Bedroom 1's bathroom · design review F-05 · accept the route (A) or a private bathroom (B)? · Taif / Palm House V8.1 · STUDY ONLY

2 Nov 2026, after the stair flip (option B, F-b) · bedroom 1 is the north-east room over the maid wing, 15.75 m² on axes, 13.9 m² clear, one room without a bath · nothing in the design files changes until the owner decides · all sizes assumed

bedroom 1 · A · 1 m = 0.95 cm · north up · brown dotted = the ground floor below

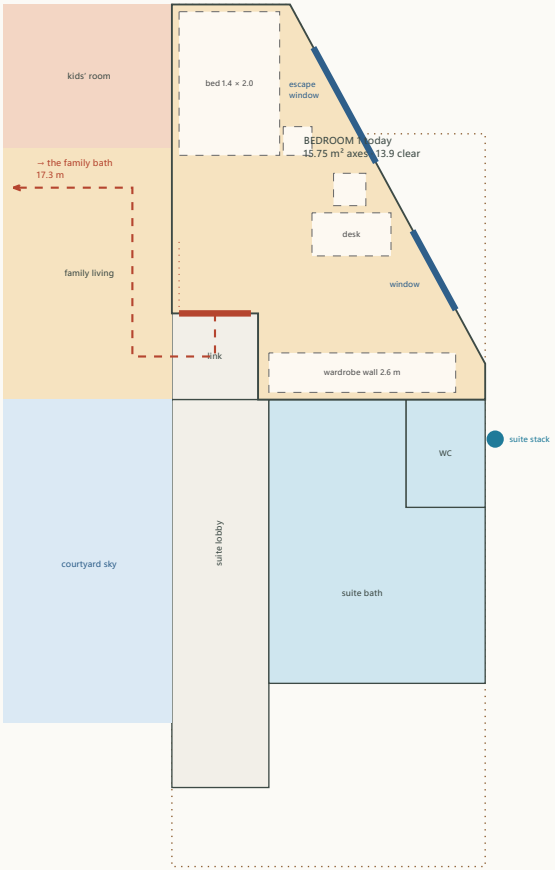
- **The walk, measured after Part 1** (the stair flipped, the family bath enlarged northwards; its door stays at x 4.25, y 9.3–10.3): bedroom 1's door → the family link → the family living, behind the sofa → the gallery's north part, past the stair arrival → the gallery → the bath's door: **17.3 m** (the same as before the flip: the bath grew, its door did not move). Five spaces, two of them lived in (the living, the gallery).

- **Who shares the family bath:** bedroom 1 (17.3 m), bedroom 2 (2.7 m), the kids' room and the family living (a bedroom later); bedroom 3 and the suite have their own. Since F-b it has **two compartments** (a WC by the shaft and the shower + double basin), so two children at once.

- **Comfort:** a child or a guest in bedroom 1 crosses the **family living** at night and in the morning, in sight of whoever is there; 17 m is the longest bathroom walk in the house (the suite's is 0, bedroom 3's 2.7, bedroom 2's 2.7).

- **Cost:** nothing; the plumbing stays as it is.

bedroom 1 · B2 · 1 m = 0.95 cm · north up · brown dotted = the ground floor below

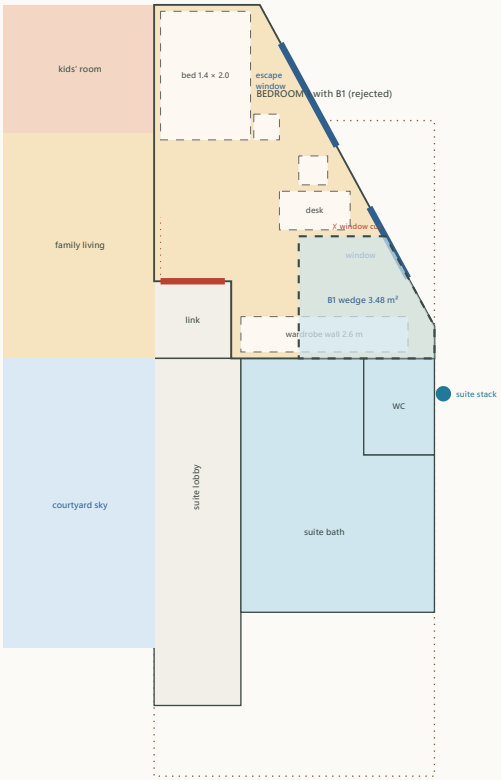
- **B2 (the best, drawn):** a bath along bedroom 1's **south wall**, x 10.6–13.311, y 5.0–6.5, its east end following the cut wall: **3.79 m² on axes, 2.49 × 1.3 clear less the slant ≈ 3.0 m²**: a walk-in shower 0.9 × 1.2 at the east end (its corner 0.02 m west of the cut wall), the WC in the middle facing north, the basin on the west wall, a **sliding 1.0 m door** from the room (no swing), a **small window on the cut wall** (y 5.35–5.85, sill +1.60, obscured). It is **next to the master suite's wet stack**: the pipes run 2.5 m east in the bath's own floor zone to the suite's stack outside the east wall (y 7.05), **over the GF maid room only** (the kitchen and its hood zone start at y 7.0; nothing over the master bedroom).

- **Bedroom 1 with B2: 11.96 m² on axes, ≈ 10.3 m² clear** (was 15.75 / 13.9): the bed 1.4 × 2.0 stays on the west wall with its bedside table, the desk and chair under the escape window, the wardrobe wall (2.6 m) becomes **two wardrobes, 1.3 m on the bath's wall and 0.9 m on the west wall** (2.2 m in all); the door's swing stays clear; the **escape window stays the room's** (the fire study unchanged); the second window (y 4.15–5.25) lights the desk. Still a full bedroom (a 1.4 bed, a desk, 2.2 m of wardrobe), no longer a two-bed room.

- **Drain:** the shower, the WC and the basin to one branch running east along the bath's south side to the **suite's stack** outside the east wall (y 7.05), 2.5 m; the branch crosses the room's south wall line at x 13.311 and turns south outside the wall for 0.6 m (or a second stack beside the suite's; the MEP engineer). **Over the GF maid room only**: not over the kitchen (y ≥ 7.0), its hood zone (the east wall y 10.2–11.2) or the master bedroom (x 8.95–13.311, y 11.9–19.25).

- **Structure (`studies/structure.typ`):** the maid wing's first-floor bay is a **solid 0.20 slab** spanning east–west 4.36 m to the cut wall; a 0.15 depressed zone cannot be cut from 0.20. Two ways, the engineer's choice: **(i)** cast the bay 0.35 thick under the bath with its top depressed 0.15 (as the suite bath, X10), or **(ii)** keep the slab and run the pipes **below** it in the maid room's ceiling void (the maid room gets a gypsum ceiling anyway; 3.1 m clear left) with a wall-hung WC and a shower tray raised ≈ 0.10. The bath's walls are light partitions on the slab (no beam; B6 at y 6.5 is the room's south wall beam, untouched).

- **Windows:** the bath's small window on the cut wall faces the lane side (obscured glass, a vent); the room keeps both its windows. **Ventilation:** the window plus an extract fan to the roof riser is not available here: an extract through the cut wall (a small louvre) or a duct in the ceiling void to the east wall.

- **Neighbours:** the maid room below hears the bath (pipes in a ceiling void: wrap them); the suite's WC closet shares the stack; the family link and the suite lobby are untouched; the family bath keeps serving bedroom 2, the kids' room and the living.

Recommendation: B2, if bedroom 1 is to be a guest room or an older child's room; otherwise A

- The route is the longest in the house and crosses the living: that is the real cost of A, and the only one. B2 answers it for ≈ 3 m² of the room and one more wet room; it is the only tidy position (B1 is a wedge that cuts a window, B3 takes the escape window). **Conditions for B2:** the engineer chooses the slab detail (i) or (ii); the MEP engineer the stack connection and the vent; the wardrobe split accepted.
- **If A:** keep the family bath as F-b (two compartments) and note in the house rules that bedroom 1's user has the family bath; nothing else to do.

1. **A** (accept the 17.3 m route, no bath) or **B2** (the private bath along the south wall, ≈ 3.0 m² clear, the room 10.3 m² clear)? If B2: the slab detail is the engineer's; the wardrobe split (1.3 + 0.9 m) accepted?
